**MODIFICATION REQUEST:**  
**Picton Regional Sewerage Scheme -**  
**Scheme Boundary Expansion**  
**Picton, Thirlmere and Tahmoor**  
**(1997-01-15 Mod3)**

Director-General's  
Environmental Assessment Report  
Section 75W of the  
*Environmental Planning and Assessment Act 1979*  
January 2013

**Figure 2. Future Growth Areas adjacent to the Scheme and Proposed modification**

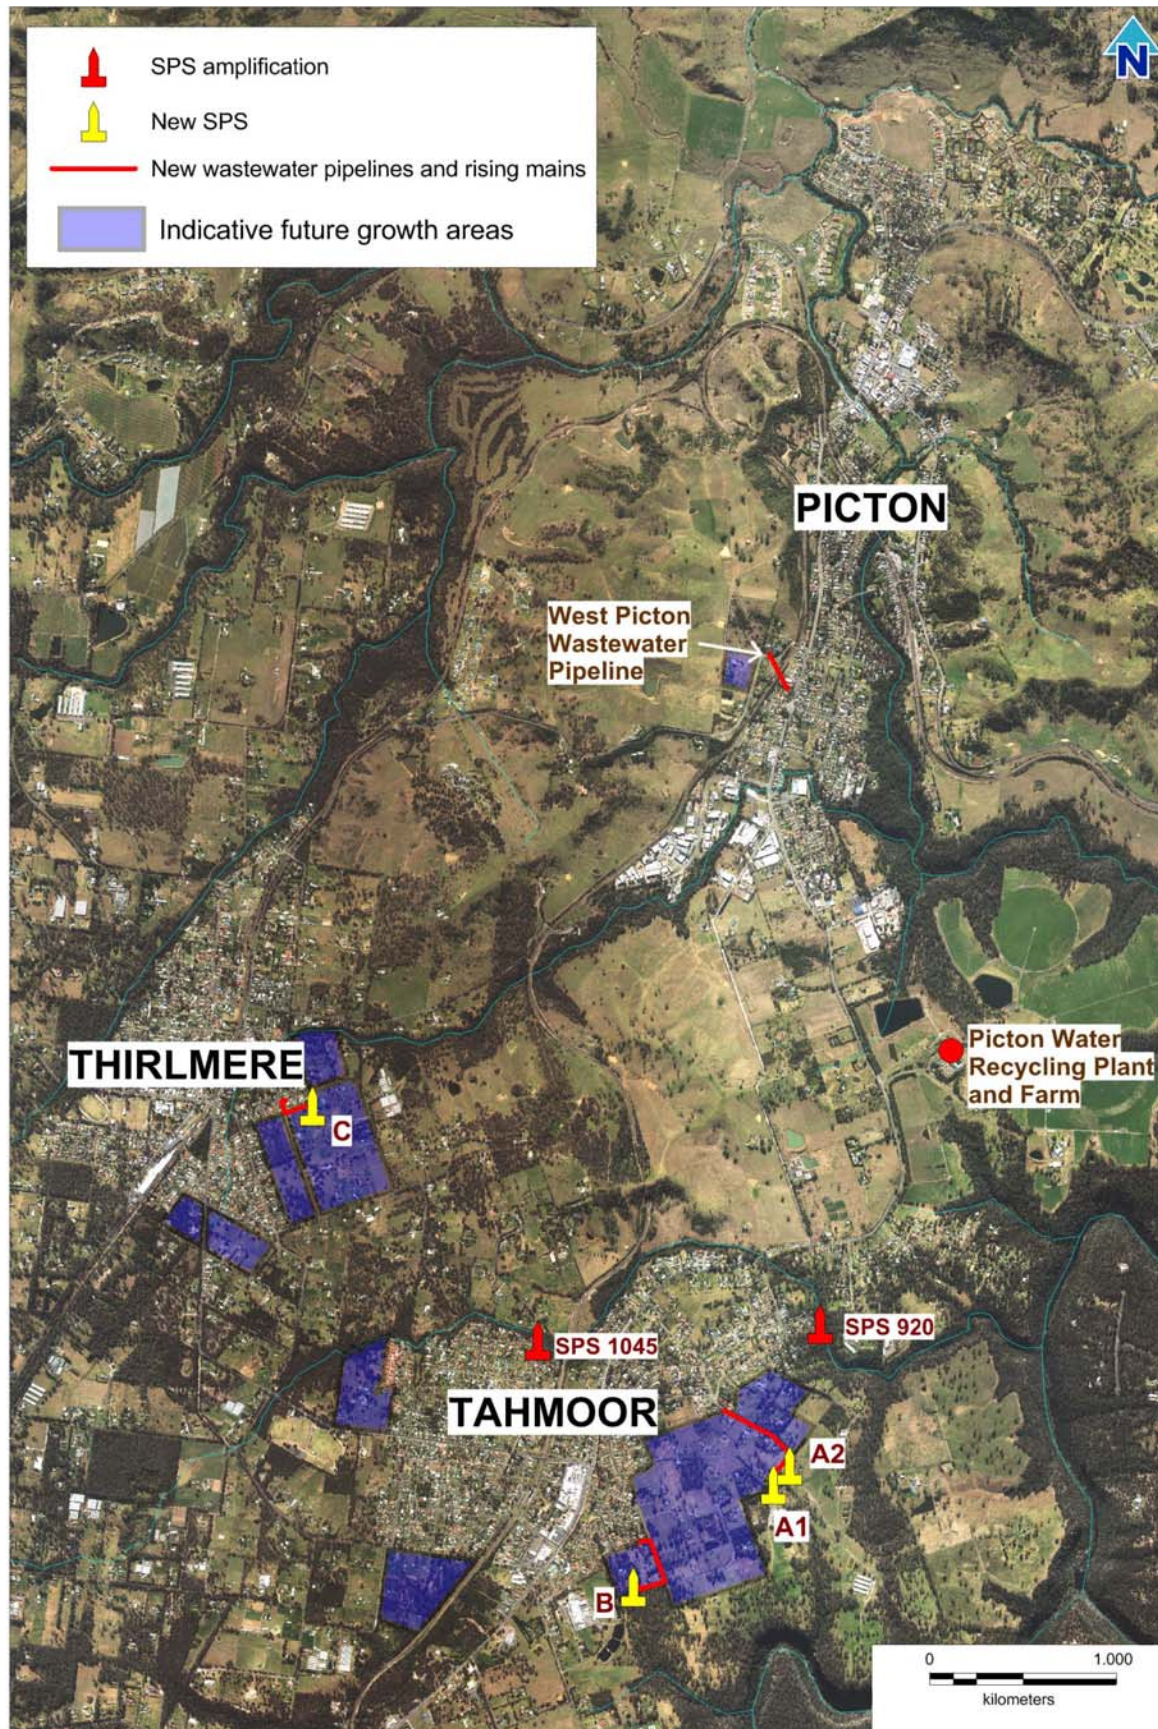
A biodiversity survey was completed for the three new rising mains and SPSs (A, B and C see Figure 2) but not for the proposed wastewater pipeline at West Picton or existing SPS 920 or SPS 1045 as they occur in disturbed areas and are unlikely to require the removal of vegetation during construction.

Two potential locations were assessed for SPS A (see Figure 3); A1 involving the removal of up to 15 *E. tereticornis* trees and A2 requiring no trees to be removed. SPS B may require the removal of one mature native tree and no trees are required to be removed for SPS C.

In assessing the acceptability of the biodiversity impacts, the Department has considered whether the Proponent has demonstrated that impacts on biodiversity have been avoided wherever possible and, where unavoidable, whether viable options exist to mitigate the impacts of the project. Area A1 potentially involving the removal of up to 15 trees resulting in habitat fragmentation, the reduction of the extent and condition of the EEC Shale Sandstone Transition Forest within the study area while Area A2 avoids the requirement to remove trees all together.

alternative site SPS A2 is preferable over SPS site A1 as site A2 avoids clearing EEC. The Department considers that site A2 should be pursued if at all possible and has recommended a condition of approval should Sydney Water decide to pursue site A1 instead.
